UNITED STATES PATENT AND TRADEMARK OFFICE

APPLICATION NO.	FILING DATE	FIRST NAMED INVENTOR	ATTORNEY DOCKET NO.	CONFIRMATION NO.
09/998,972	10/31/2001	Christopher Rogers	DEP 0639	6510
27777	7590	03/24/2004	EXAMINER	
PHILIP S. JOHNSON JOHNSON & JOHNSON ONE JOHNSON & JOHNSON PLAZA NEW BRUNSWICK, NJ 08933-7003			LEWIS, RALPH A	
			ART UNIT	PAPER NUMBER
			3732	il

Office Action Summary

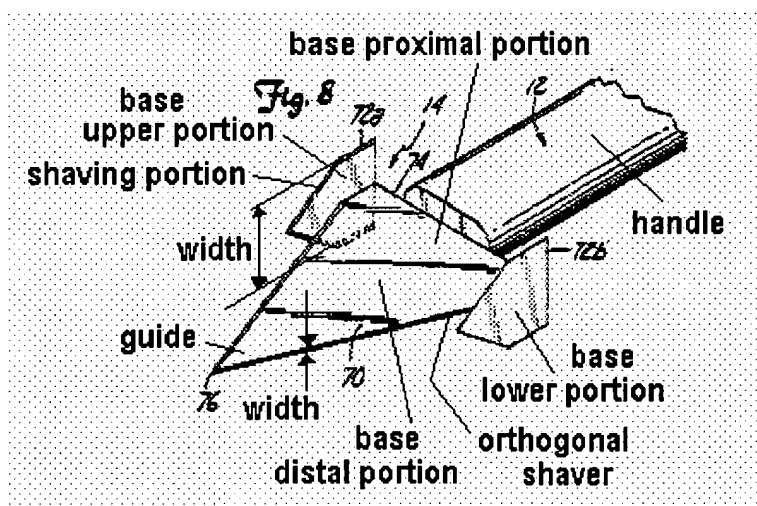
Claims 1-12, 15, 18, 22-24 and 38-44 are rejected under 35 U.S.C. 102(a) as being anticipated by Ray et al (US 5,649,945).

Note the identified structure in Ray et al Figure 8. The intent by applicant that tool be used with base upper and lower portions in a horizontal position rather than a vertical position, fails to provide for any objectively ascertainable structural distinctions between the claimed device and that disclosed by Ray et al.

In regard to claim 4, note the optional handle of Figure 9. In regard to claim 5, note the retraction means 28 (recess).

In response to the present rejection applicant argues that Ray et al fails to disclose a "guide" and then declares that a "guide is a non-cutting member that helps align the chisel if the chisel were somehow misaligned, thereby insuring that equal amounts of material are removed from the upper and lower workpiece portions." Unfortunately, the rejected claims fail to include such defining language. The examiner

would readily withdraw the present rejection if such language were included in the claim. Applicant's apparent position that the examiner and the public somehow read applicant's mind and interpret the general term "guide" in such a manner is unreasonable.
